Informal document **GRPE-82-33**

UNECE EVE-IWG In-Vehicle Battery Durability

Level of the Minimum Performance Requirement (MPR)

Possible “backstop” concept for MPR structure

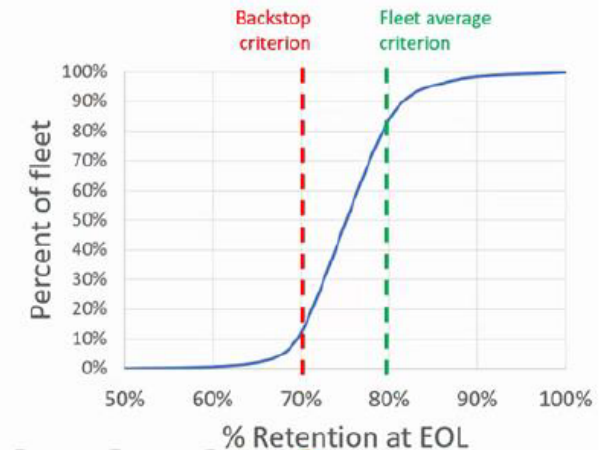
- The shape of the curve is critical as at this stage, OEMs don't know the shape of the curve: Different regions, driving profiles, battery chemistry all play into the shape, etc.
 - TEMA model cannot be used for creating the shape of that curve as TEMA model still needs further evaluation
- ➔ Phase 1 with implemented SOCC and SOCR should be used to identify the distribution in the field and the shape of the curve
